DEPARTMENT OF WATER RESOURCES

PROOF ACKNOWLEDGMENT LETTER

RE: PERMIT NO. 37-08670

STATE OF IDAHO
DEPARTMENT OF WATER RESOURCES
BENEFICIAL USE FIELD REPORT

**Site Plan - Beneficial Use Exam
WR Permit #37-08670**

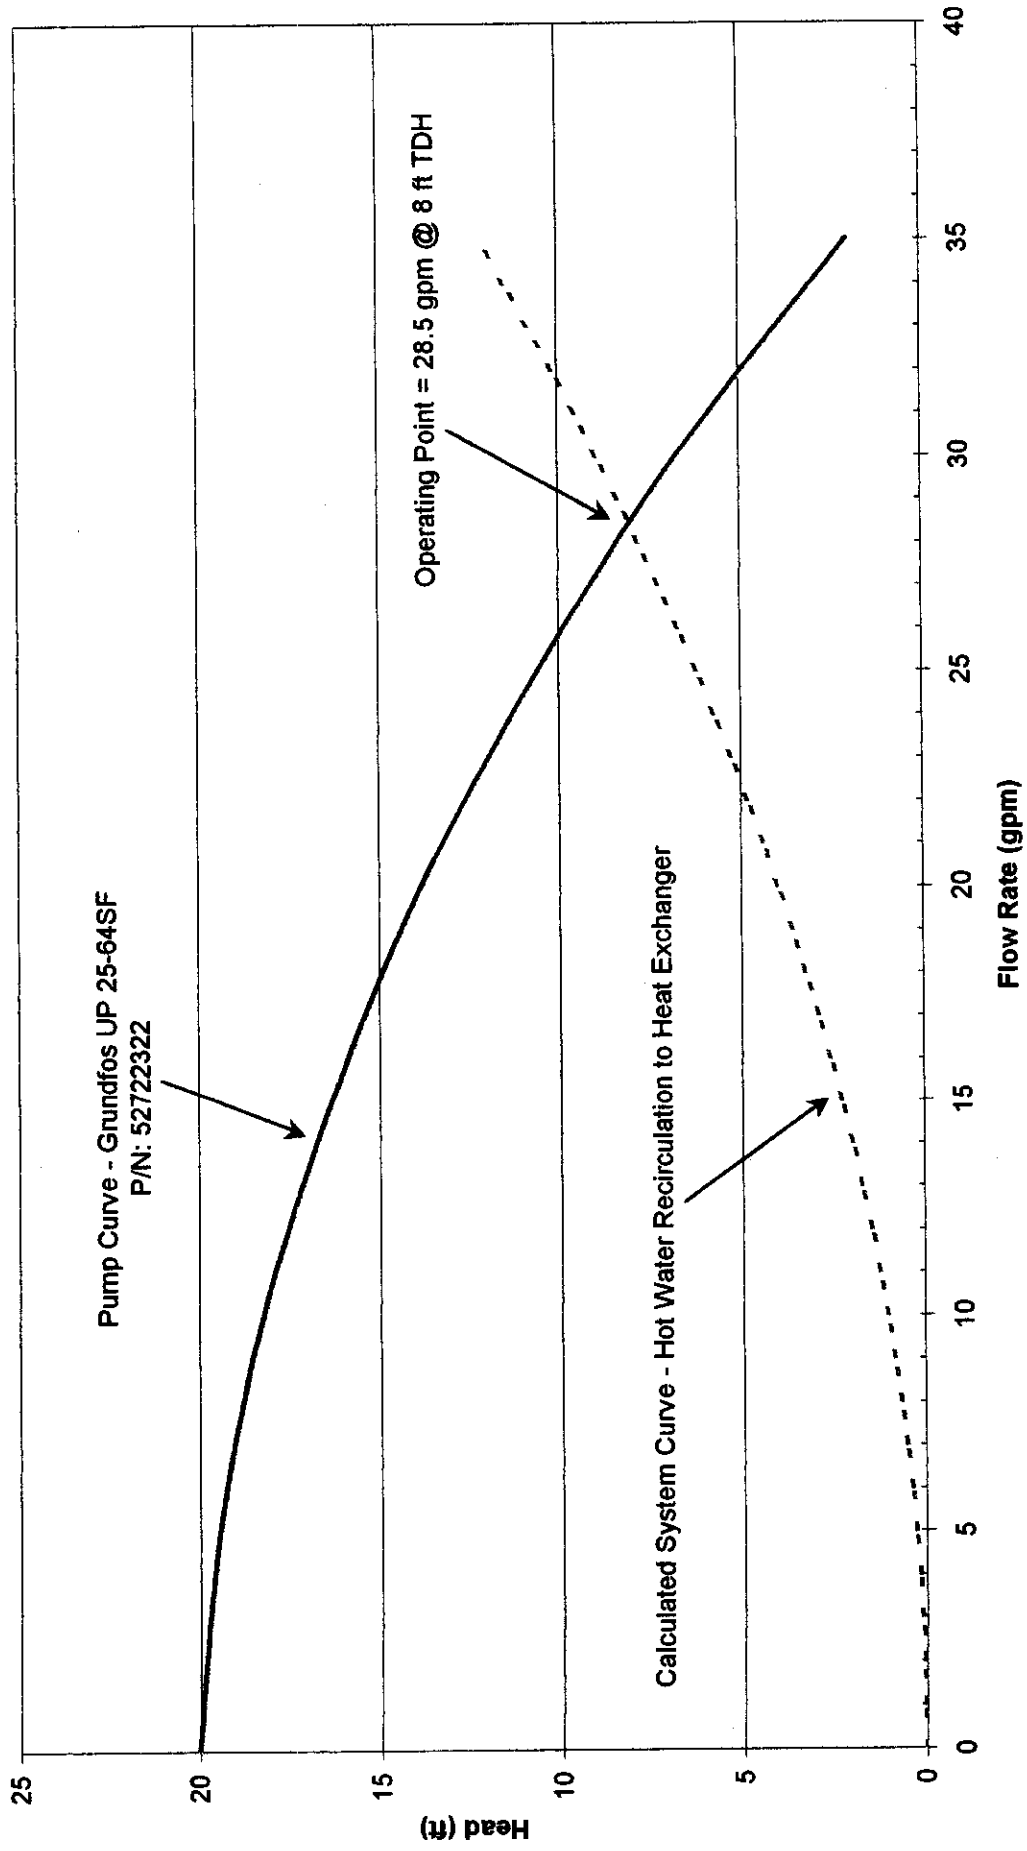
1. What is the actual source of water? The permit was issued for the development of 3 existing artesian wells. Please identify the location of the wells on the map you provided, and the relationship between the wells and the spring box development.
2. Volume amounts for each of the uses recommended, are required with your calculations attached.
3. The diversion rate recommended for wildlife uses exceeds the rate for heating purposes. The system will need to be modified to avoid any bypass of the heating uses for other purposes. Please describe how the system will be modified to utilize the hot water before it reaches the wildlife pond.
